ADDENDUM No. 2

PROJECT NAME: Alamo Plaza Visitor Information Center Office Renovation ID No.:43-00001

DATE: January 13, 2015

SHEET
A11.1

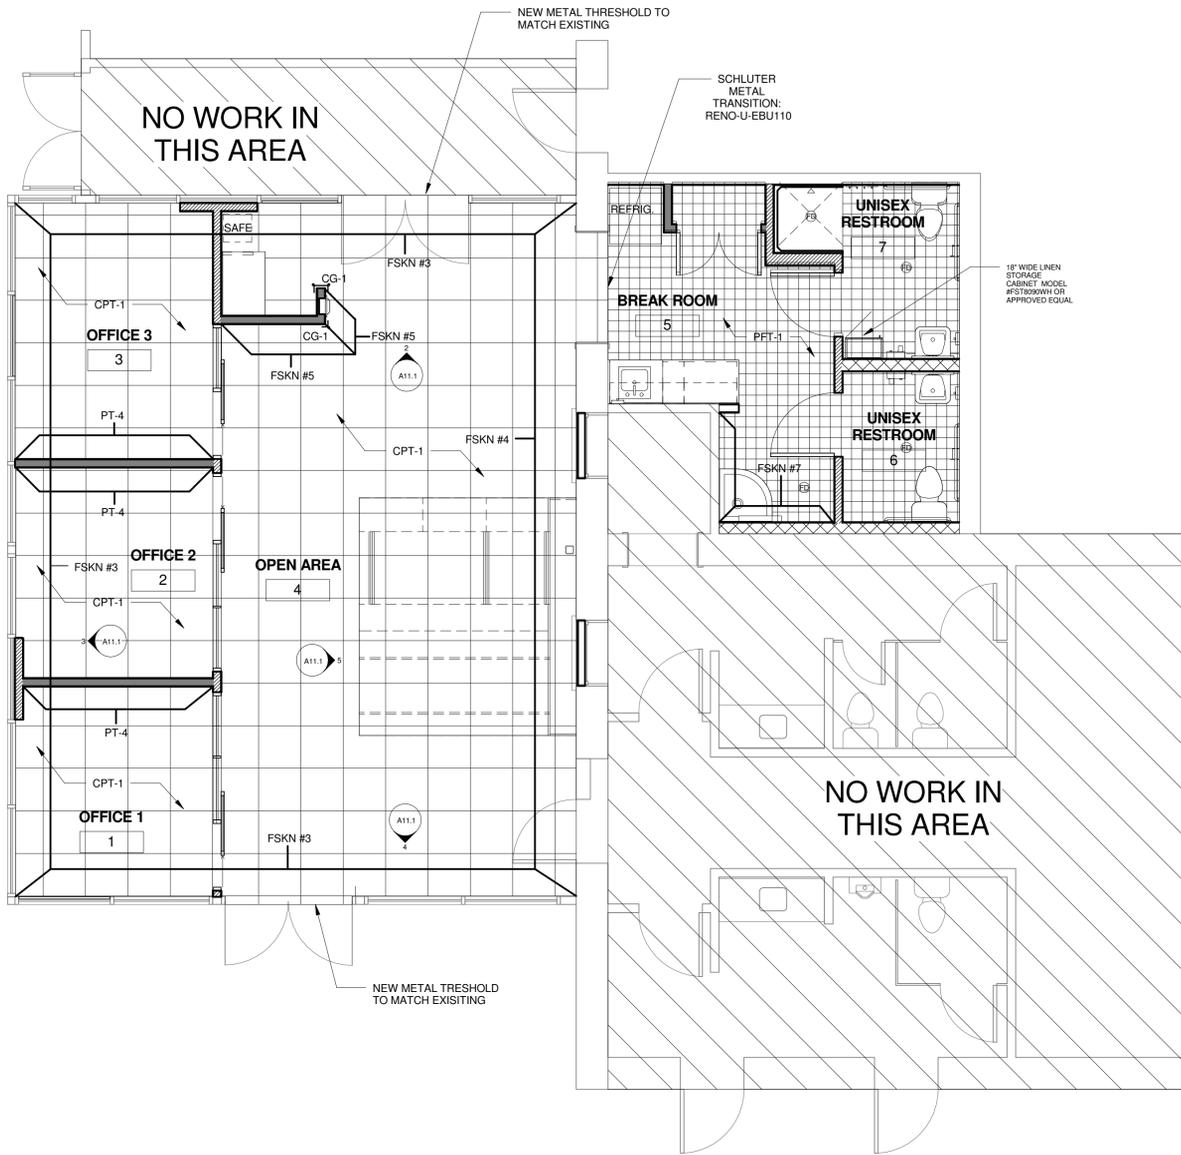
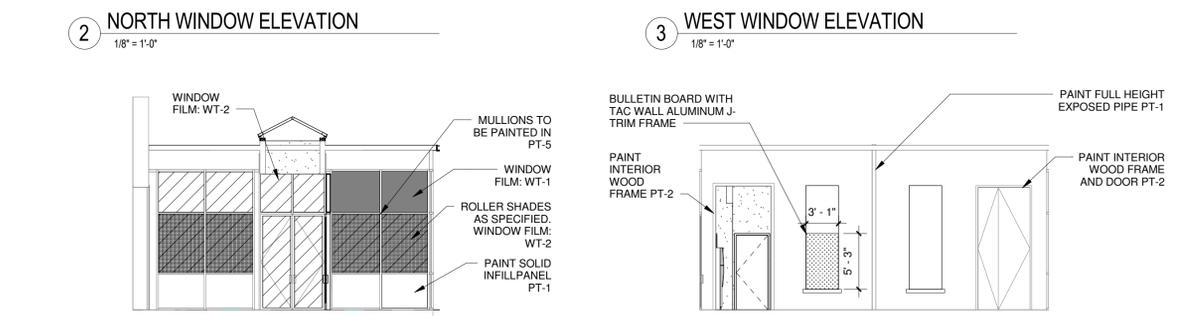
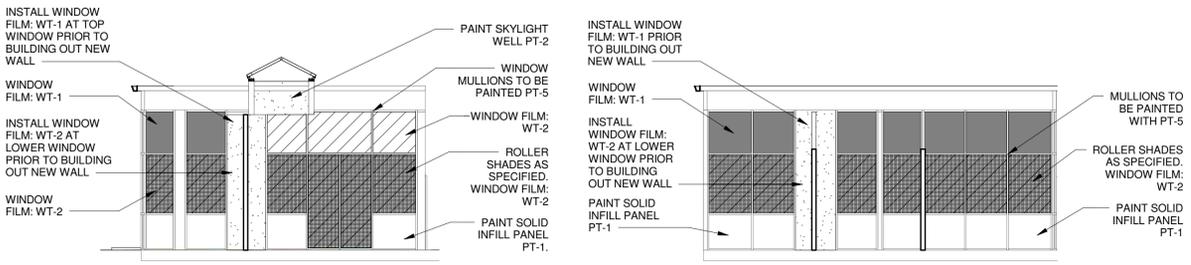
ITEM 1 REMOVE Sheet A11.1 and REPLACE with EXHIBIT 'A', Sheet A11.1

3. Question: Specify type of Corner Guards required.

Response: Refer to EXHIBIT 'A'.

EXHIBIT 'D'

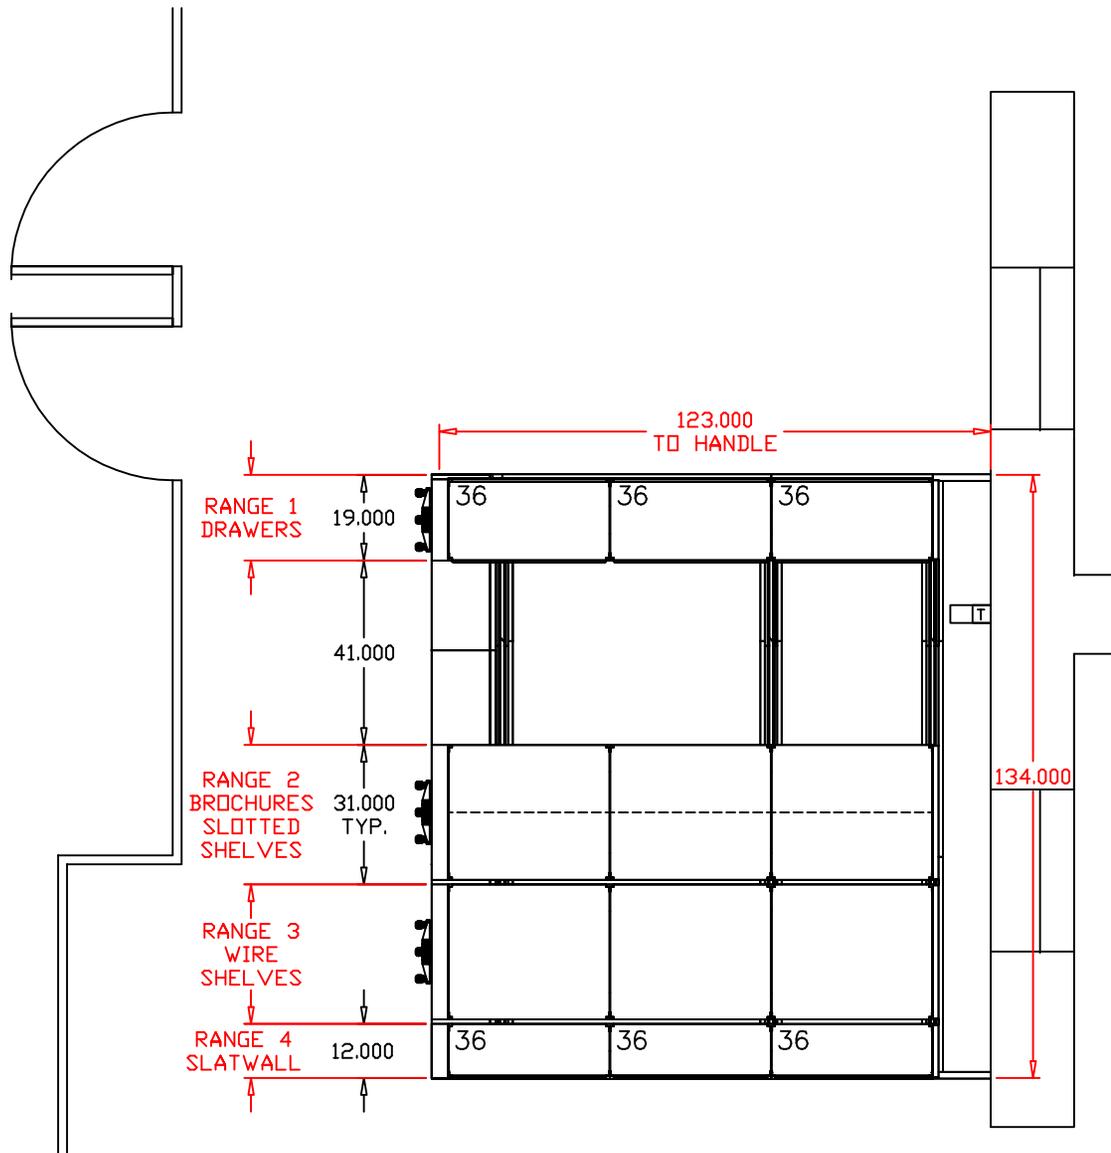
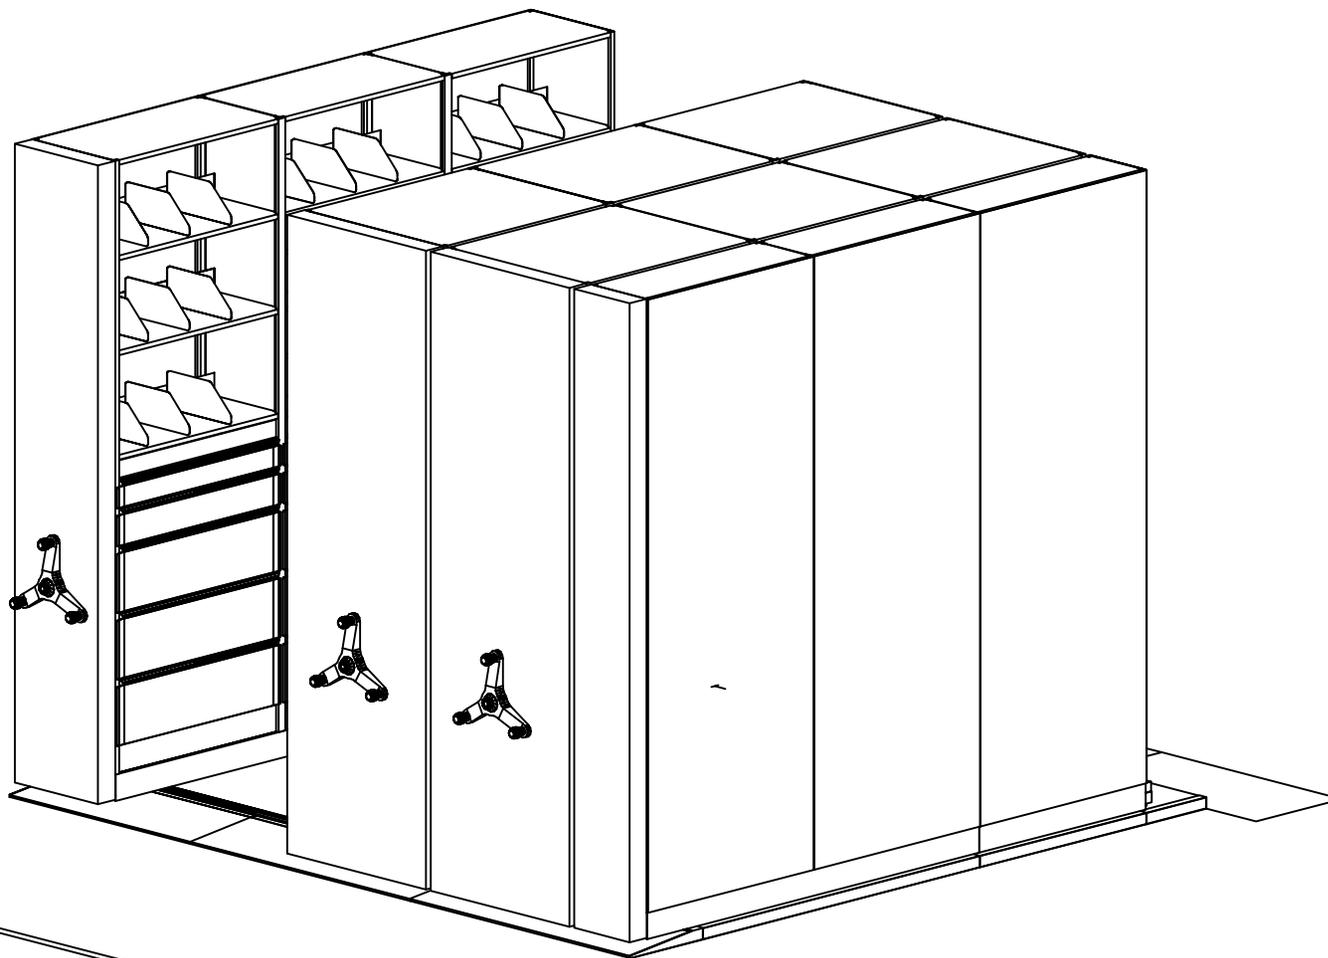
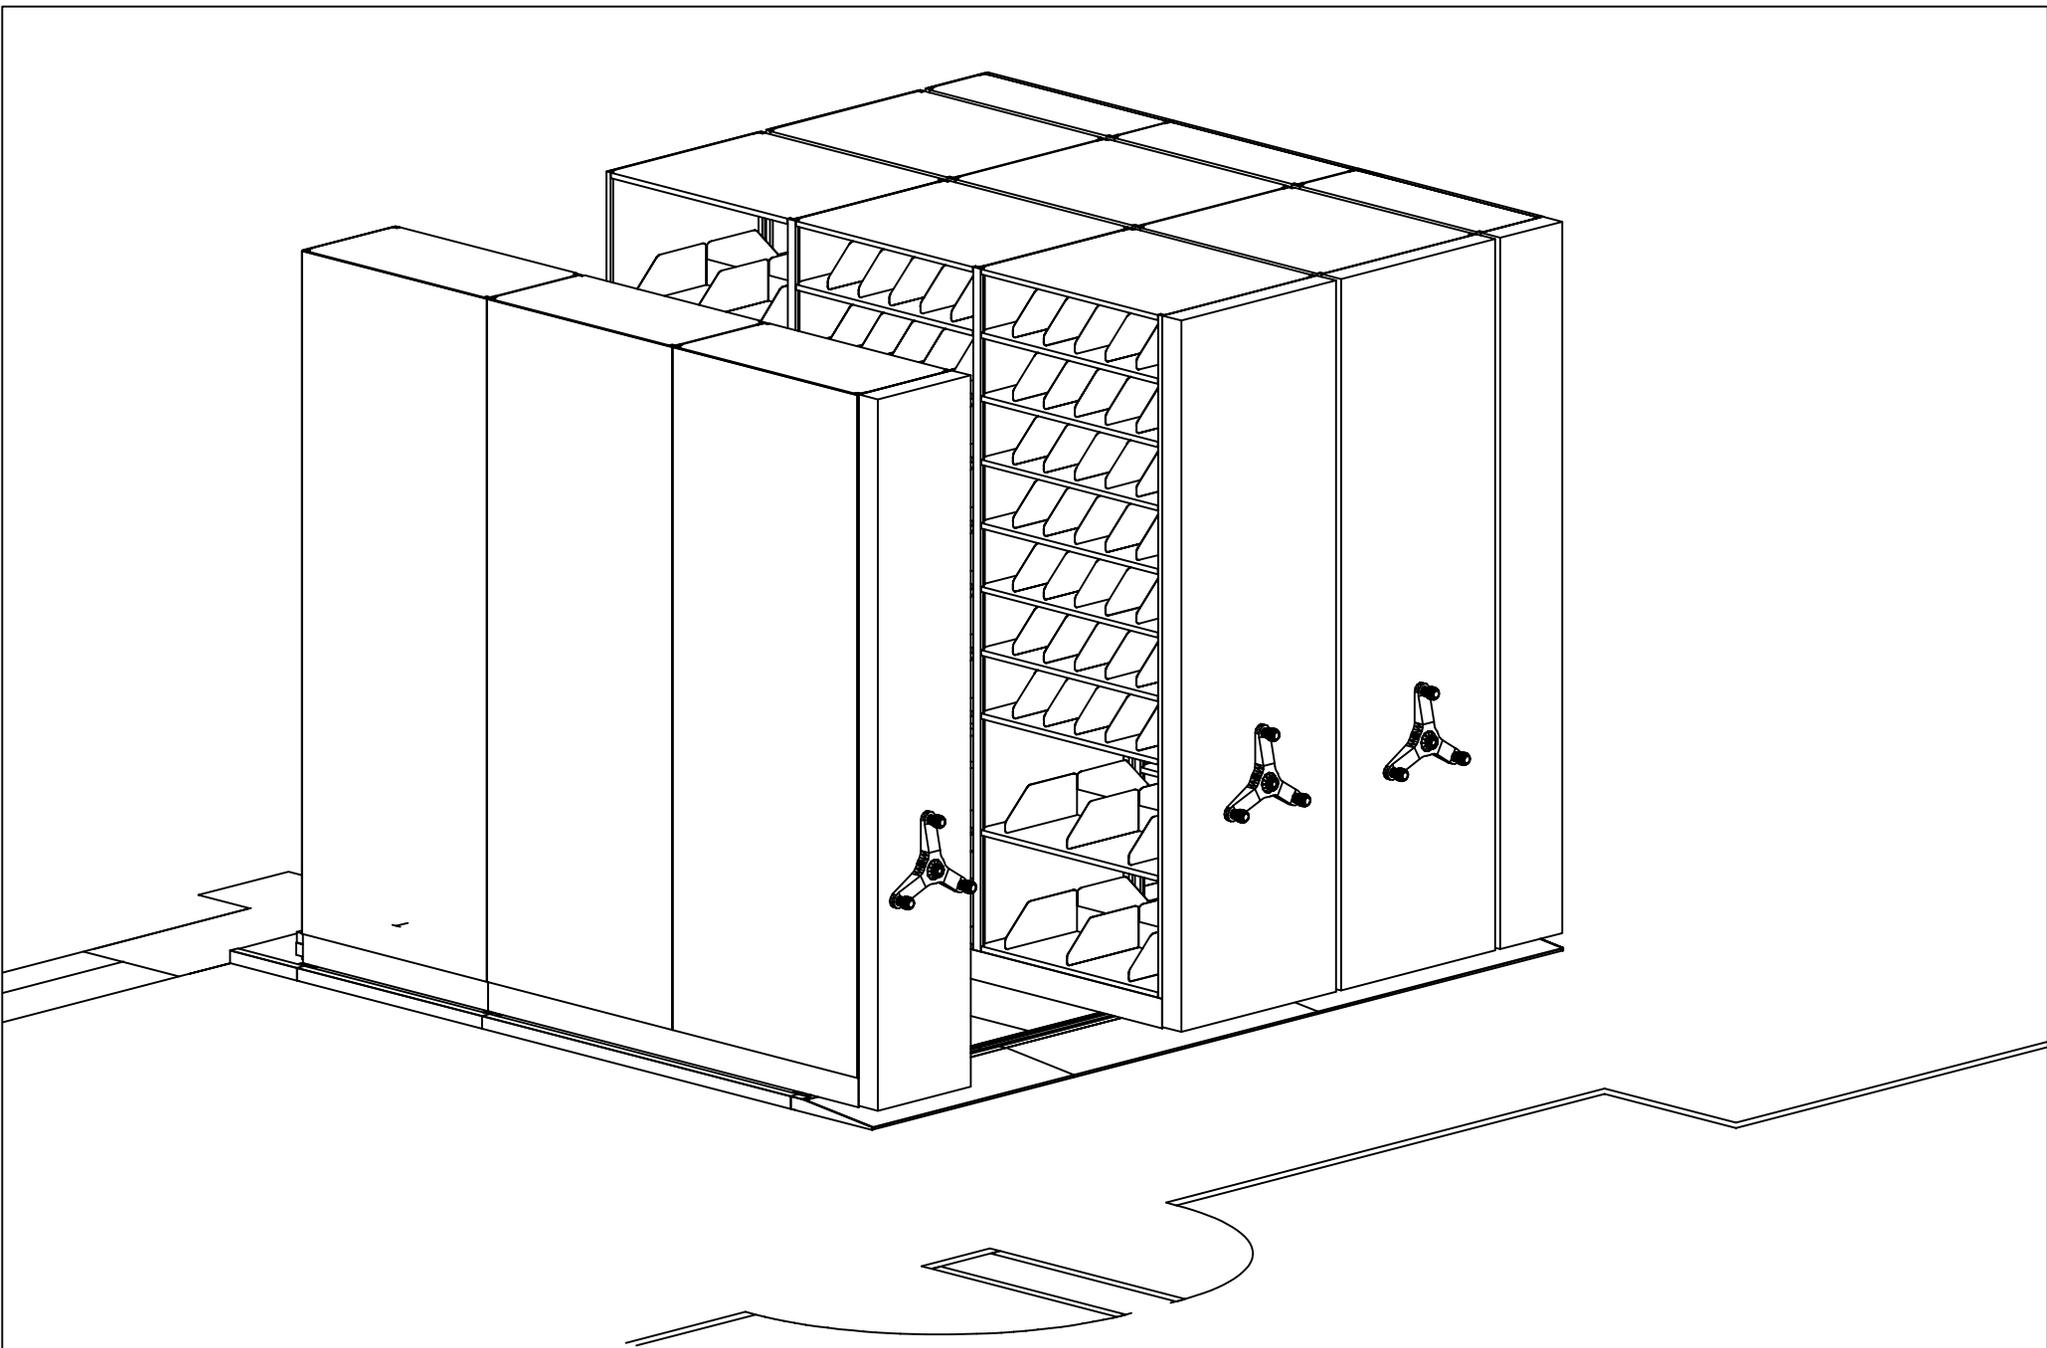
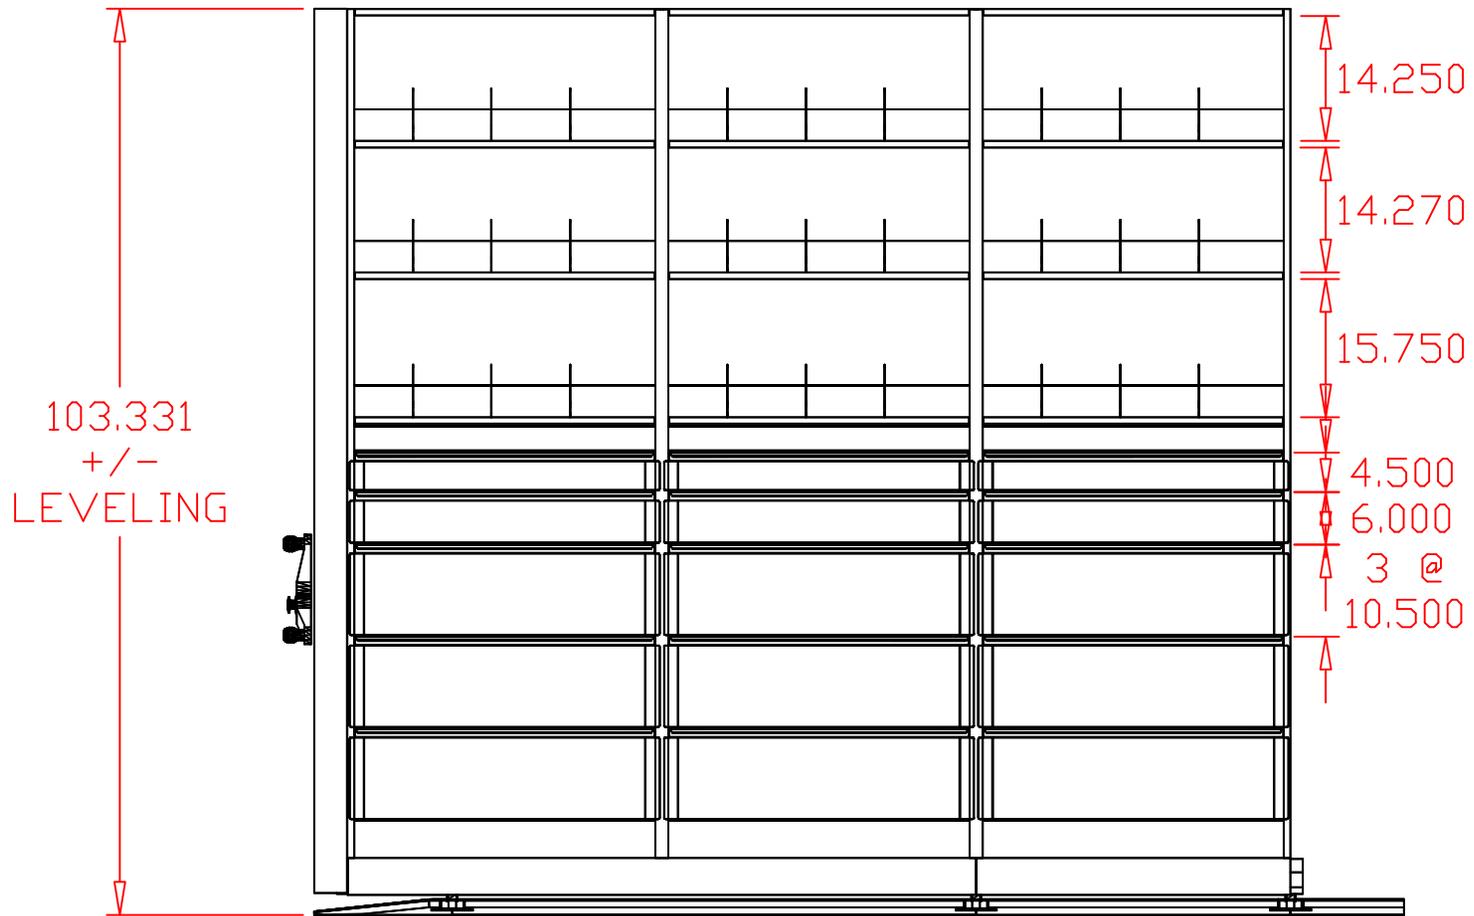
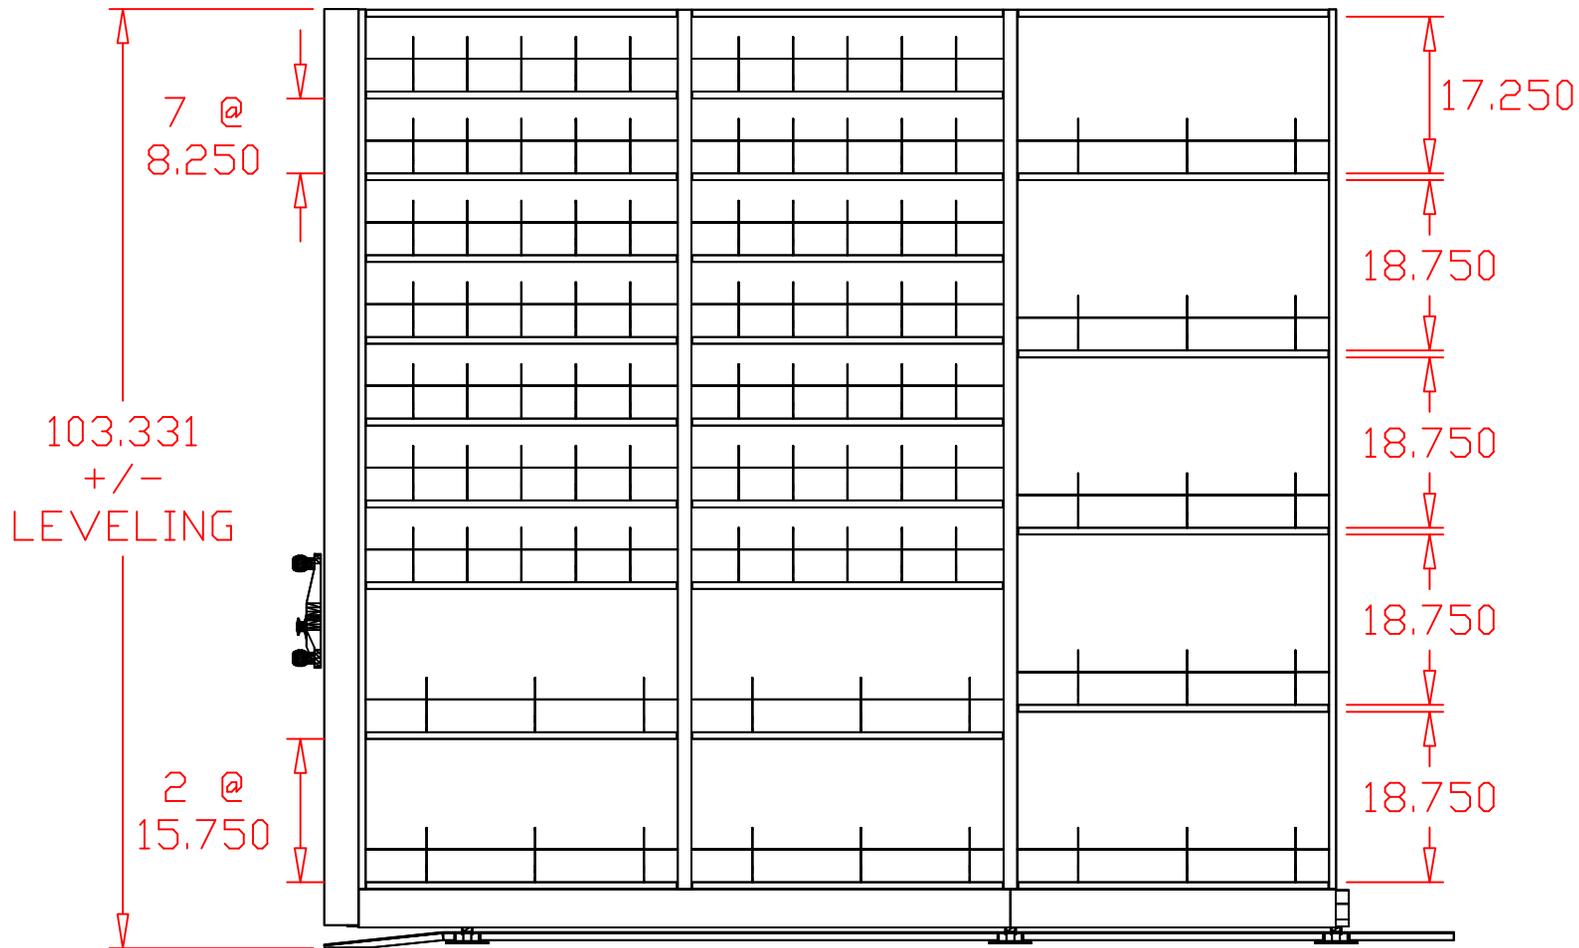
6. **Question: Where is the "New Mobile Shelving System" Specified? Not included in the specs. The Demo plan indicates for us to remove and store, are the existing to be reinstalled?**

Response: Refer to attached **EXHIBIT 'D'** for mobile shelving requirements (included in specs, but not referenced in Table of Contents. Refer to Question 8 below regarding existing shelving.
